Section 12A Application No.Y/I-DB/2

For rezoning the permissible use from staff quarters to permit flats at Area 6f, Discovery Bay
Response to Comments (5)

Section 12A Application No.Y/I-DB/2 for rezoning the permissible use from staff quarters to flats at Area 6f
Applicant's response to the departmental comments made available by District Planning Office on 7 March 2017

FIGURE 3

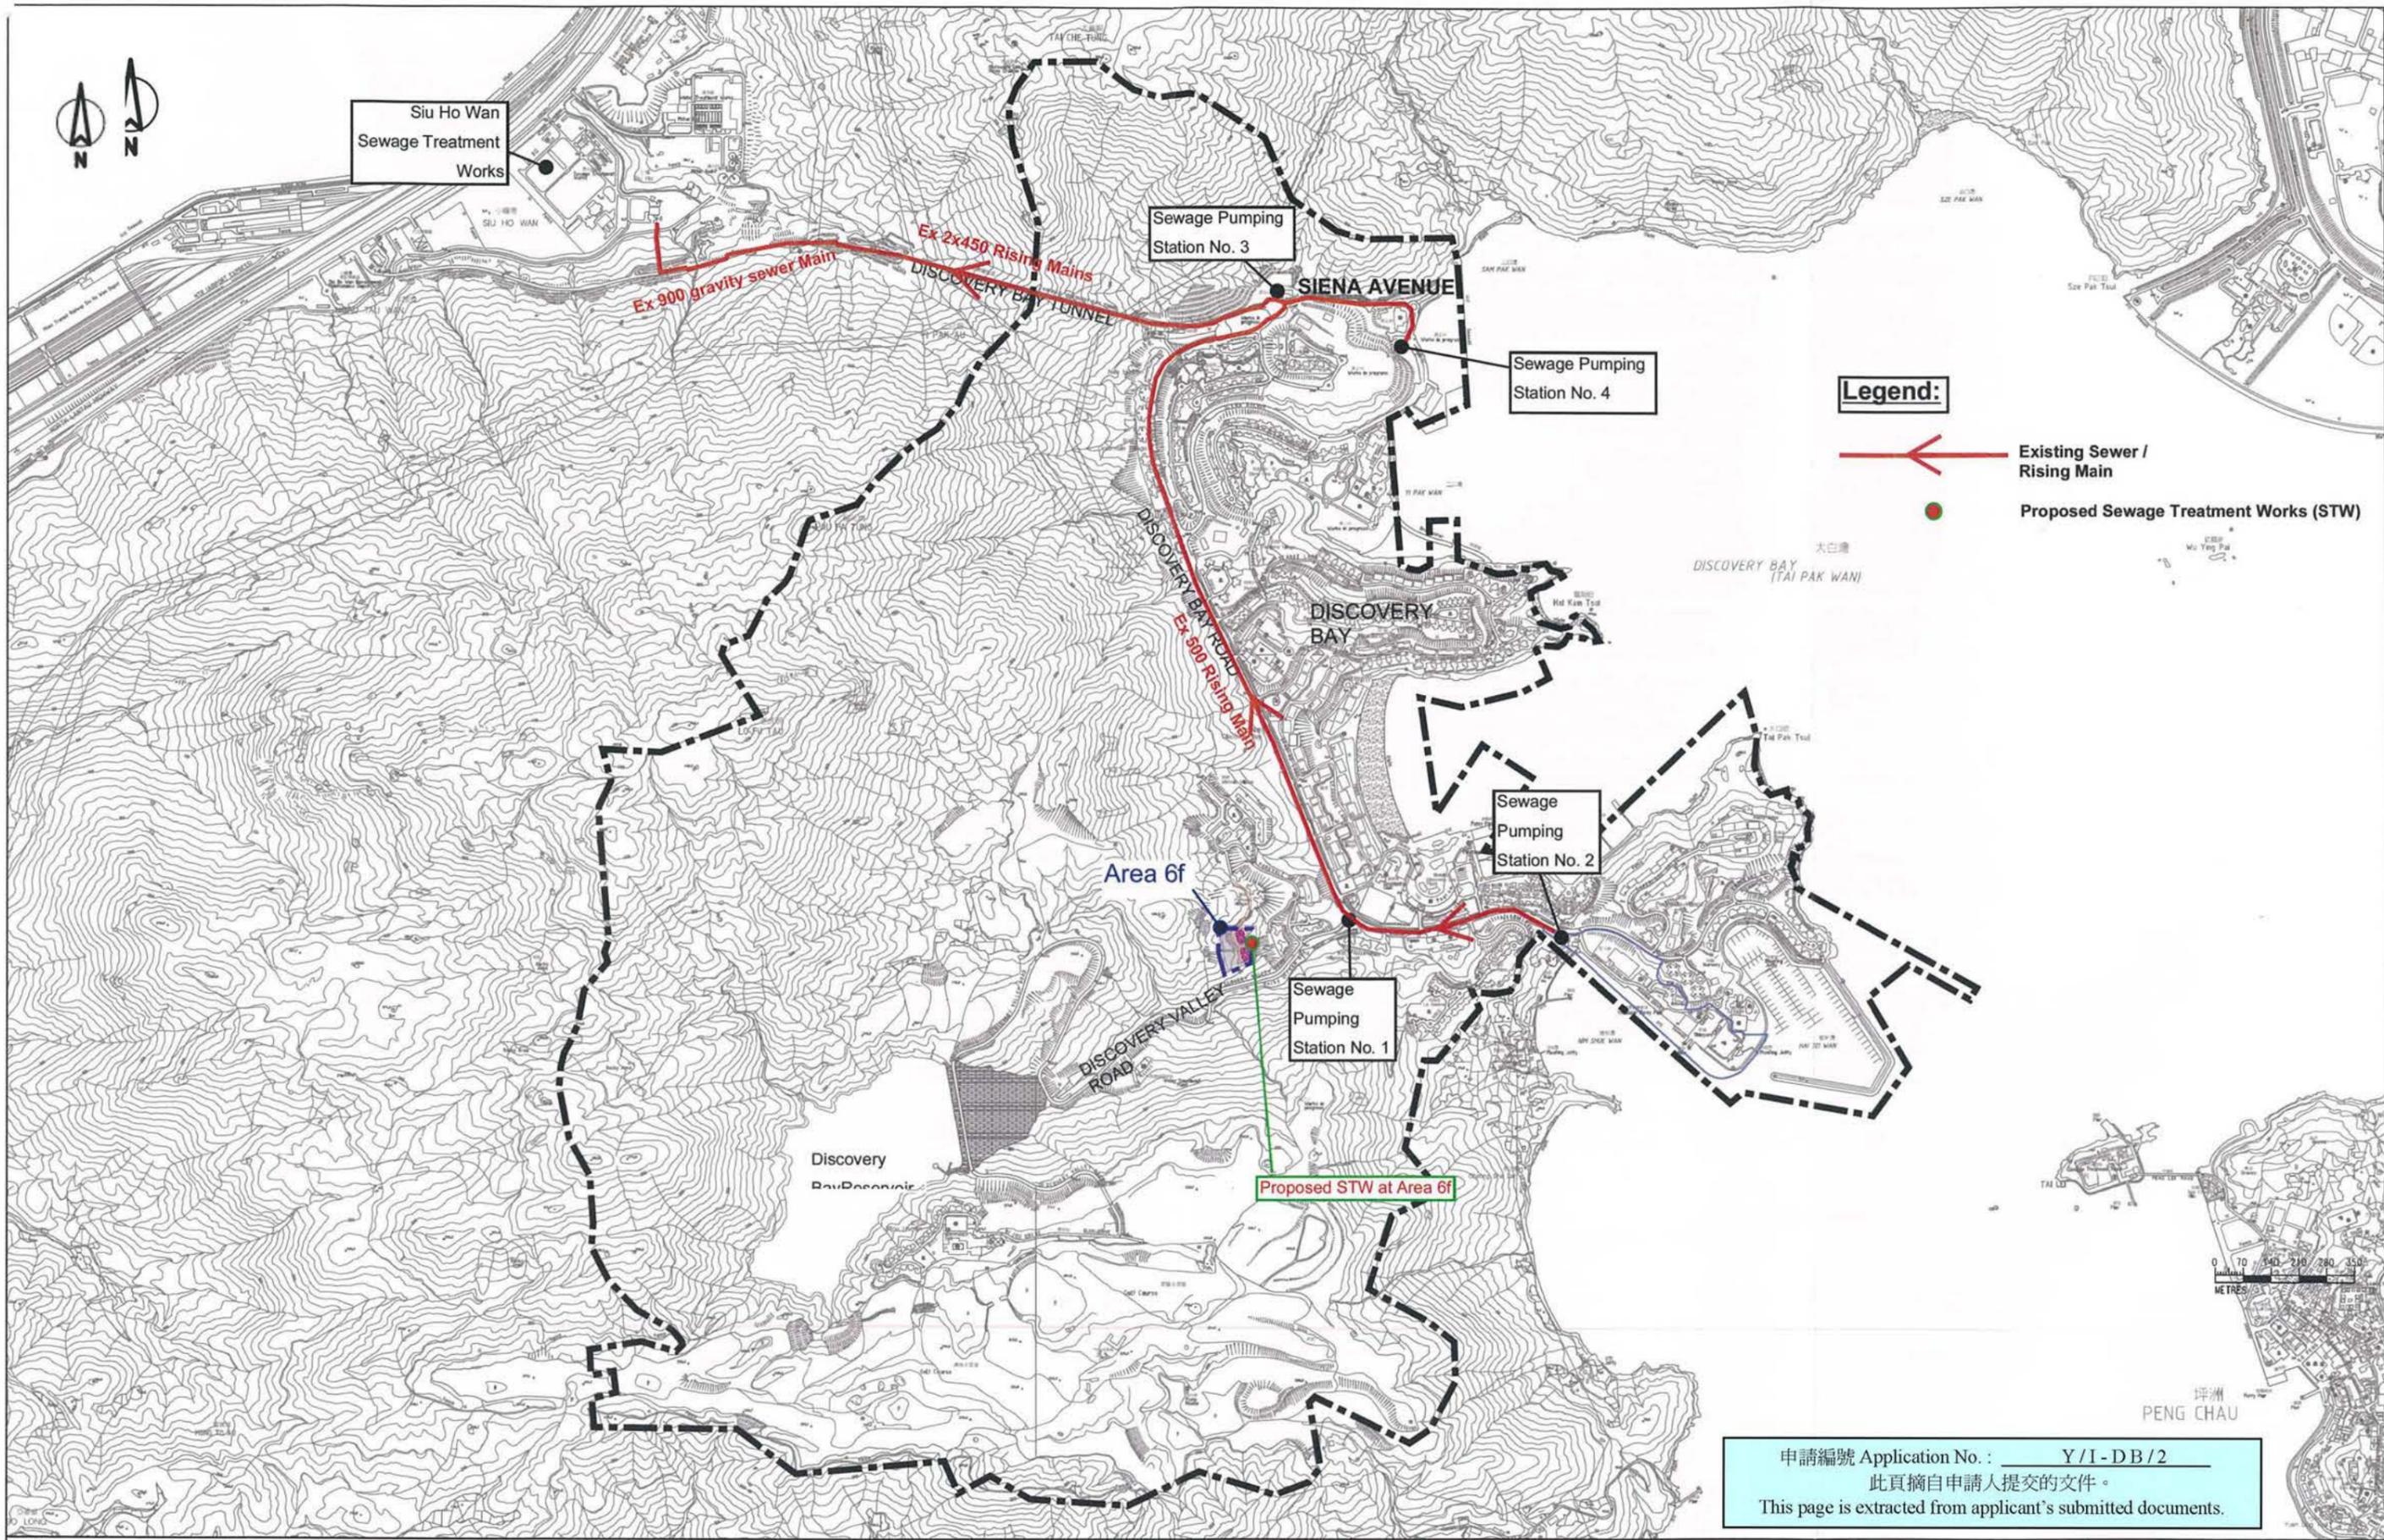
<p>DSD's comment</p> <p>Please remind the applicants to check and ensure the proposed sewage works and their downstream sewage system shall have adequate capacity and be in good conditions to accommodate the sewage collected from the application site and its upstream catchments. The applicants and the successive owners of the proposed development shall effect any subsequent upgrading of the proposed works and the downstream sewage system whenever necessary.</p>	<p>Applicant's response</p> <p>The sewage flow from the proposed development will be treated in proposed new private Sewage Treatment Works (STW), which is separate from the existing sewerage system, so the proposed development at Area 6f will have no sewerage impact to the existing Discovery Bay sewerage system.</p> <p>The contingency measure of overflowing sewage from the proposed private STW to the existing Discovery Bay Sewage Pumping Station (SPS) No. 1 during emergency situation when the STW fails, was also proposed in the technical assessment report. Capacity check of the existing downstream sewerage system has been carried out and it is found that the downstream sewerage system are adequate to accommodate the sewage collected from</p>

the application site under emergency situation and its upstream sewage catchments. Please find relevant revised paragraph 5.7.1.3 of the Environmental Study in **Appendix C** for details.
